DOCUMENT 00 90 00
ADDENDUM

ADDENDUM No.: 4

DATE: March 6, 2025

RE: WESTERN TECHNICAL COLLEGE
AUTOMOTIVE TECHNOLOGY CENTER ADDITION AND REMODEL
2721 LARSON ST.
LA CROSSE, WISCONSIN 54603
PROJECT NO. 24061

1 EQUIPMENT PLAN - SEGMENT B
1" = 10'-0"

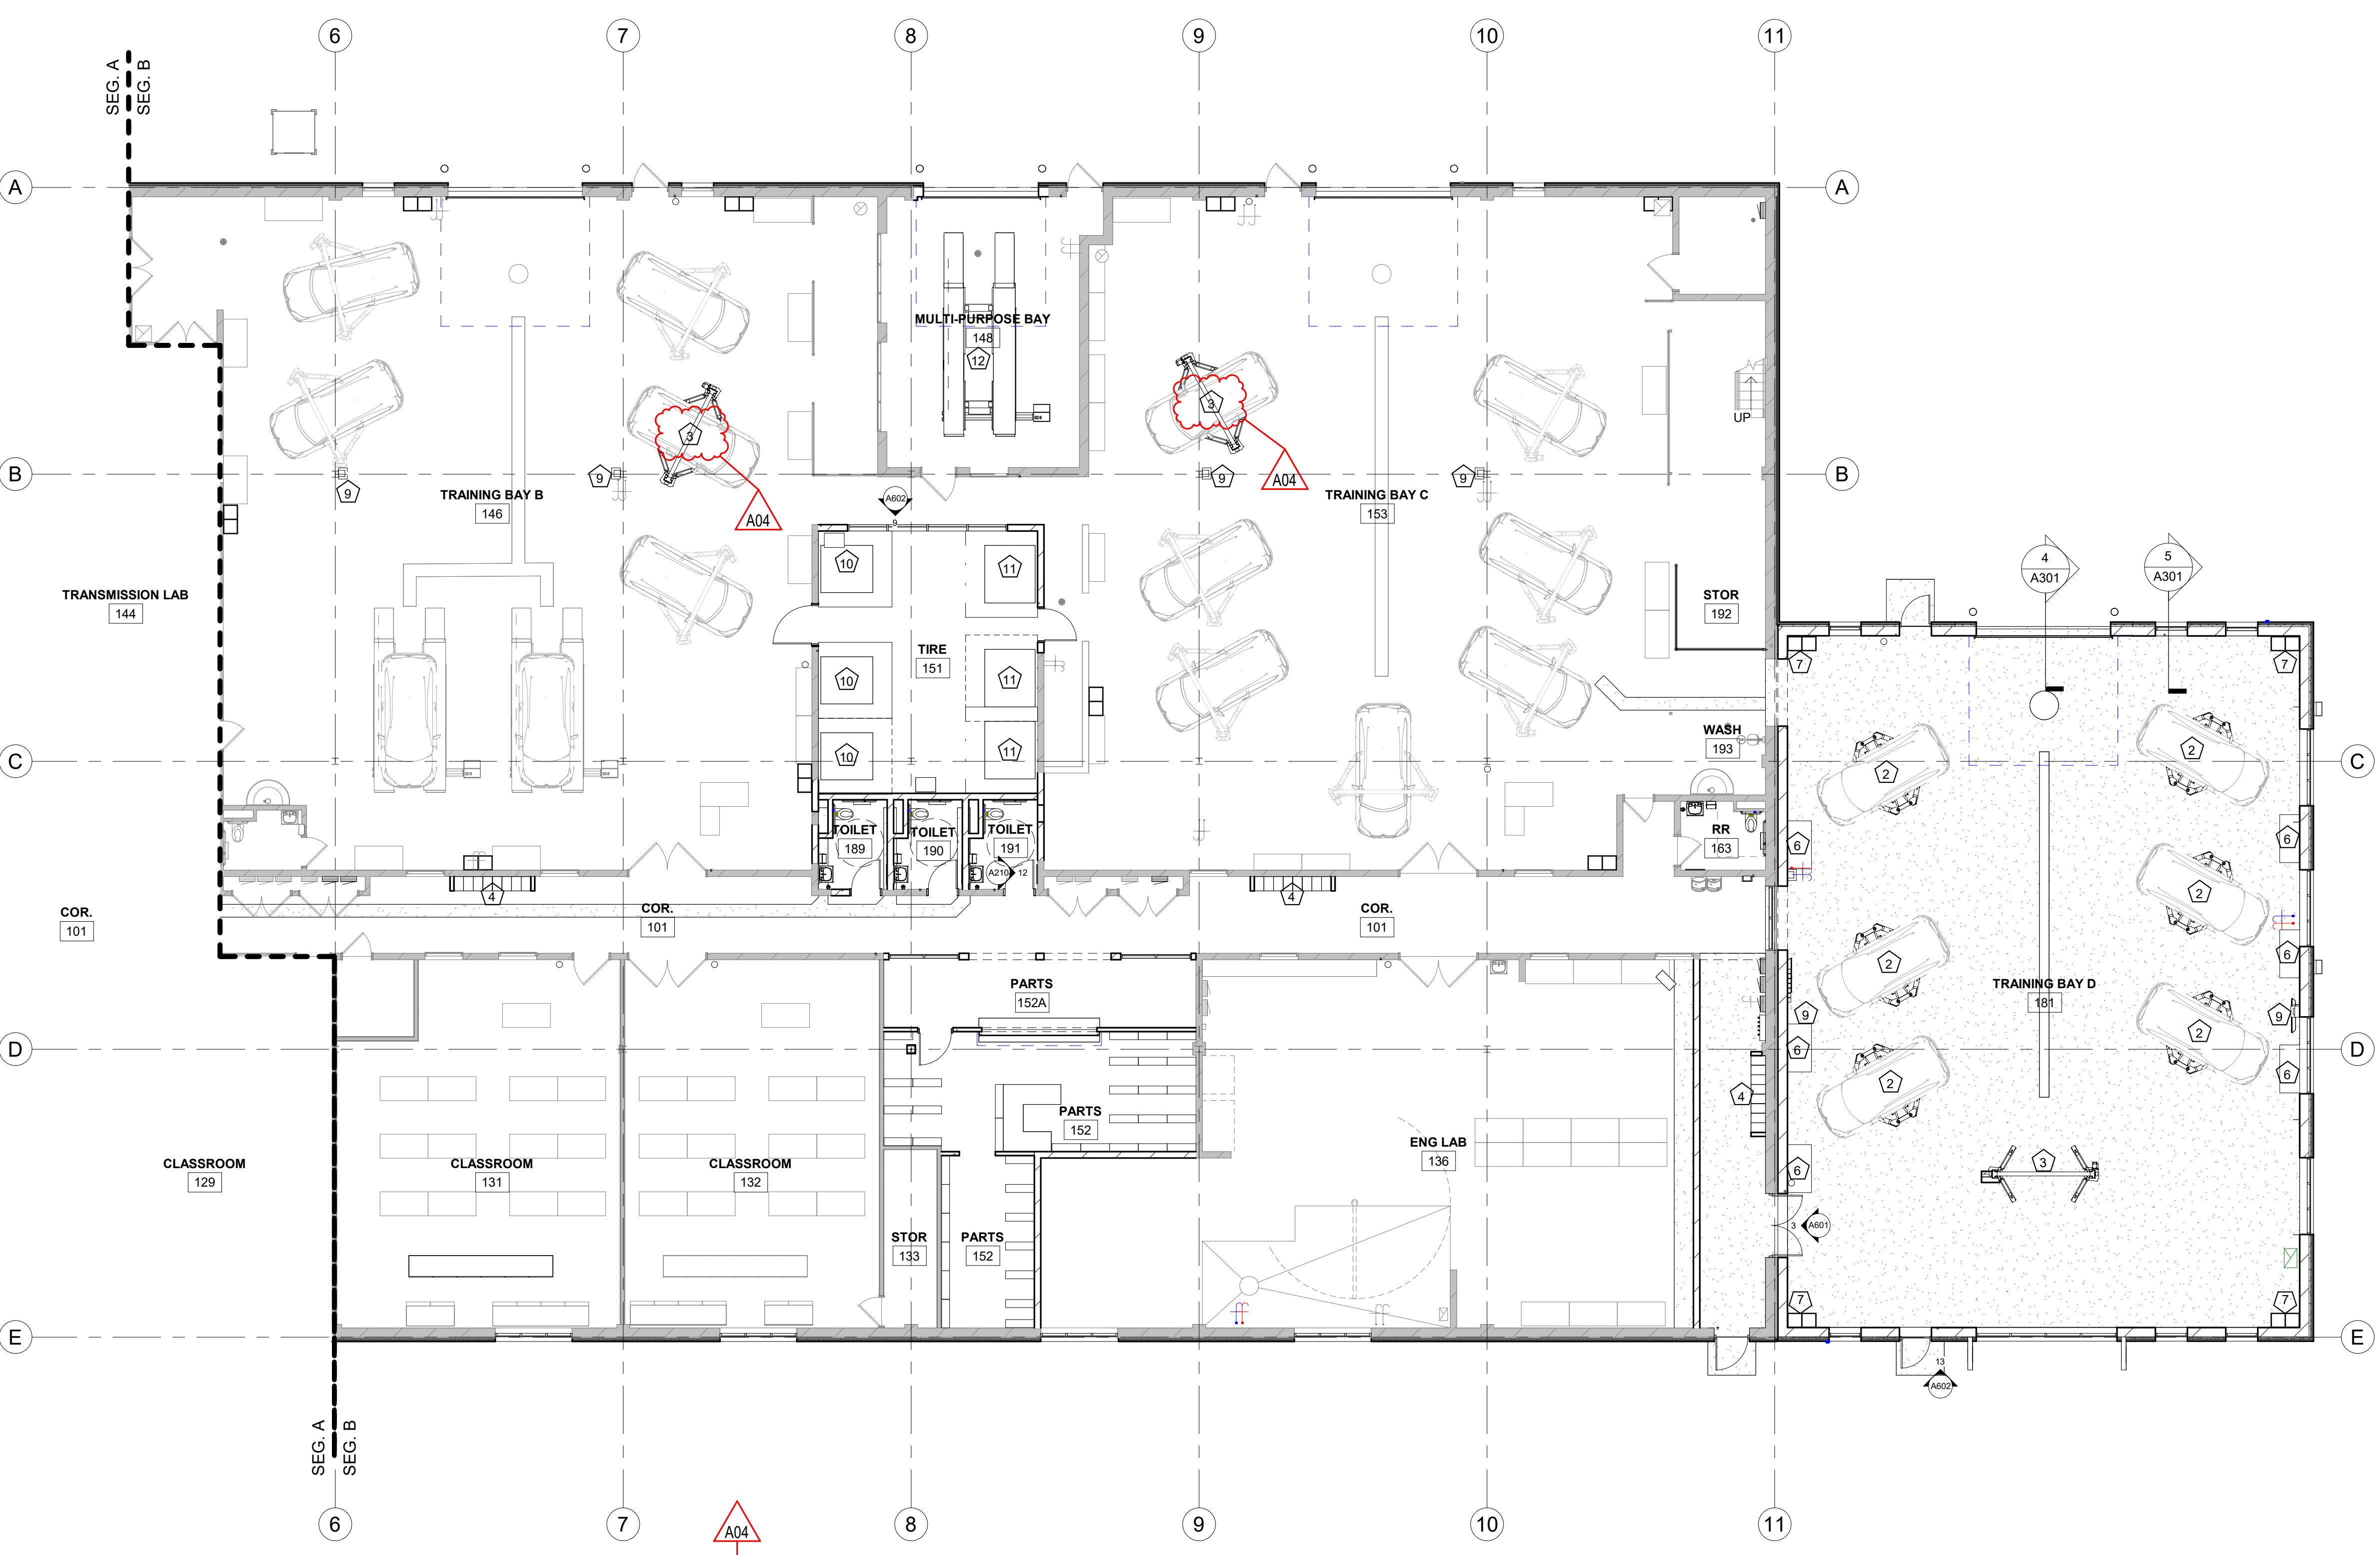
11. Sheet A141 EQUIPMENT PLAN – SEGMENT B 30"x42"

- a. See the revised sheet included in this addendum. Disregard the previous version.
- b. Revised equipment callouts at auto lifts.
- c. Revised title of Equipment Plan to add the “- SEGMENT B”.
- d. Revised the Equipment Schedule.

12 RESTROOMS 182, 189, 190, 191, 163
1/2" = 1'-0"

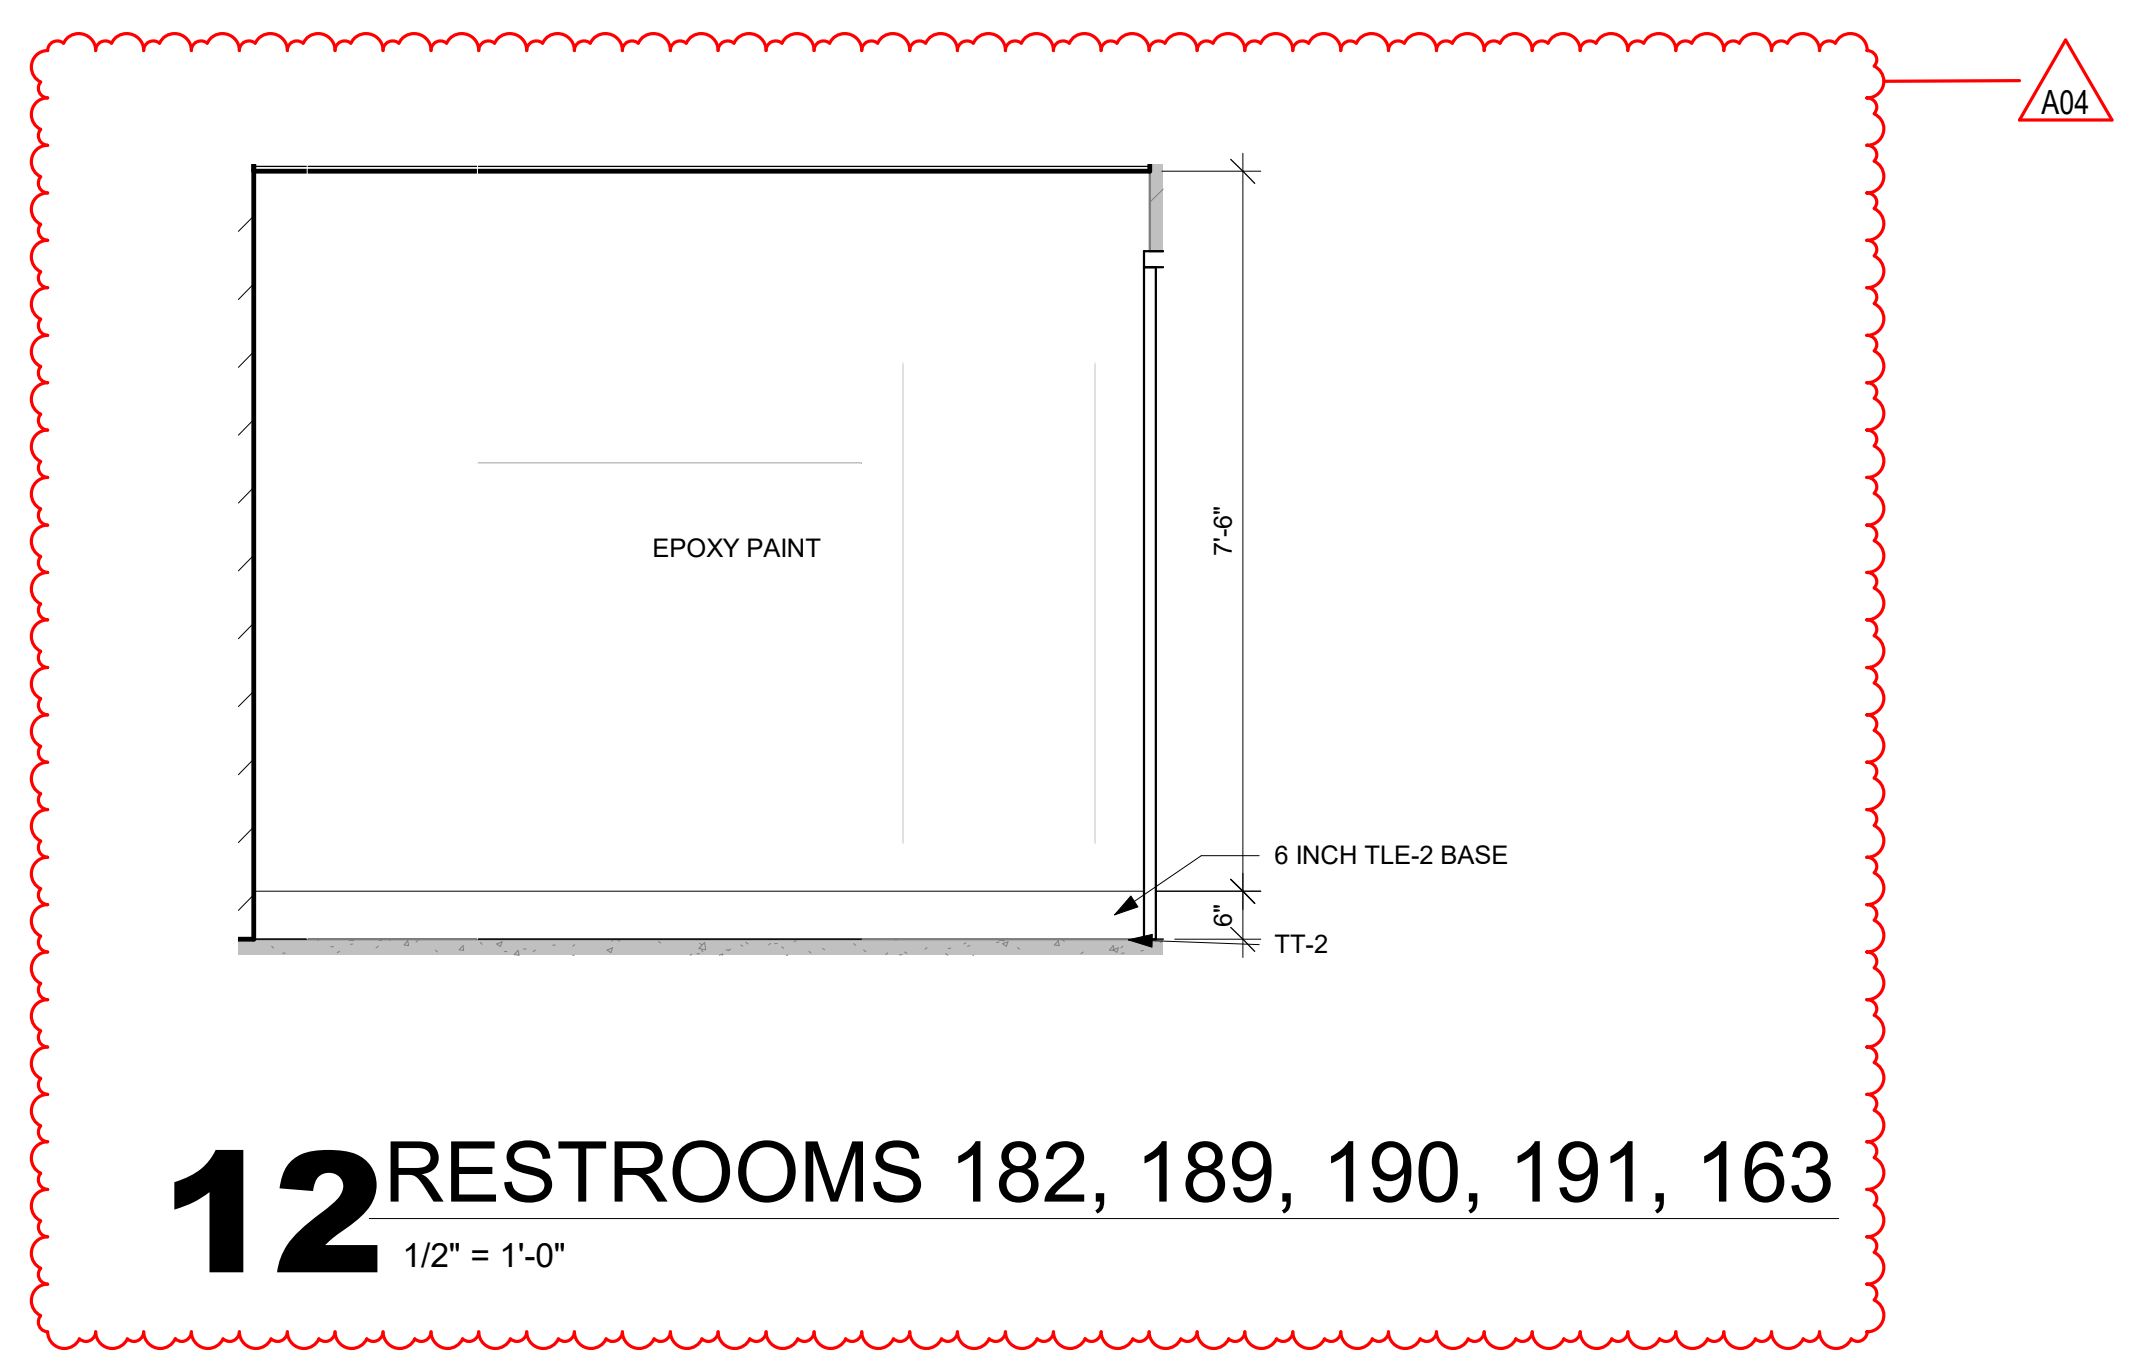
14. Sheet A210 CASEWORK & INTERIOR ELEVATIONS 30"x42"

- a. See the revised sheet included in this addendum. Disregard the previous version.
- b. Added elevation 12 to clarify tile scope at restrooms.

13 FRAME ELEVATION
1/4" = 1'-0"

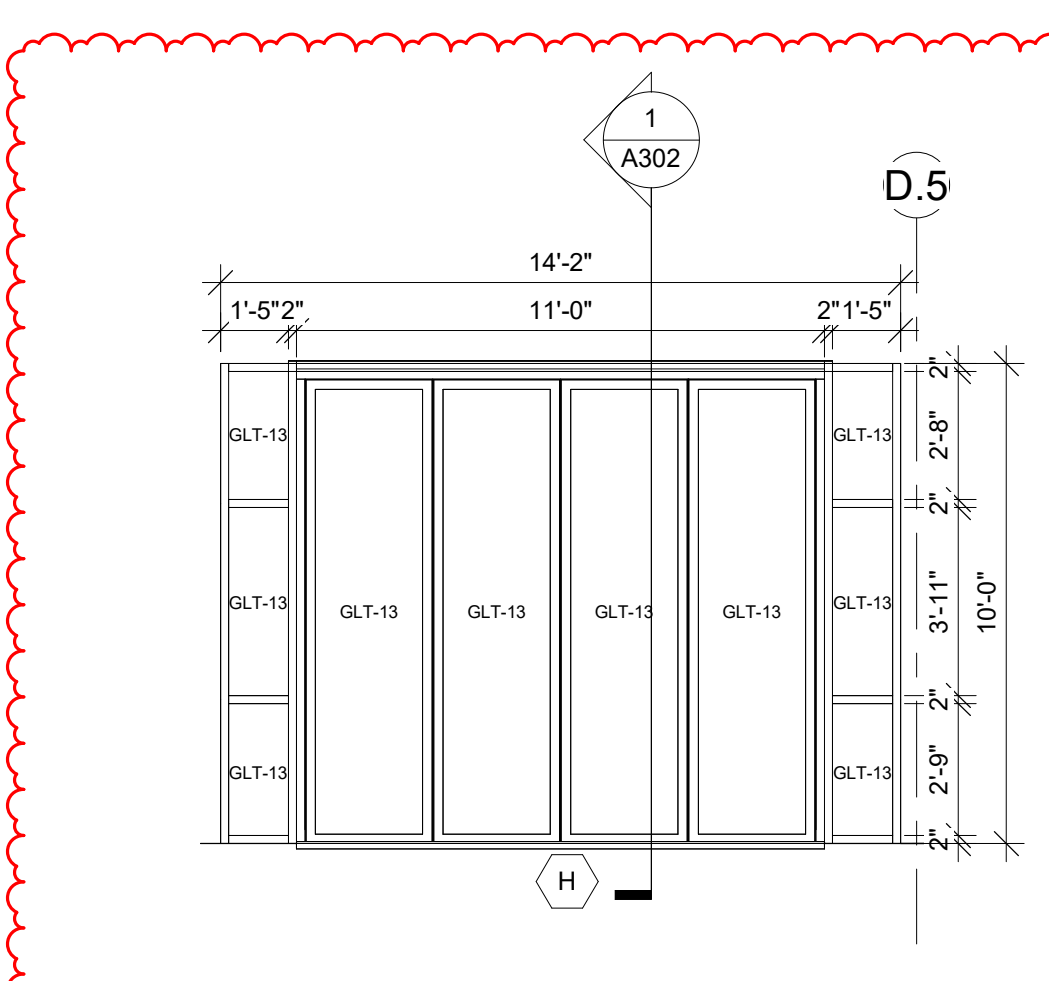
16. Sheet A602 FRAME ELEVATIONS 30"x42"
 - a. See the revised sheet included in this addendum. Disregard the previous version.
 - b. Added frame elevations 13, 14 & 15.
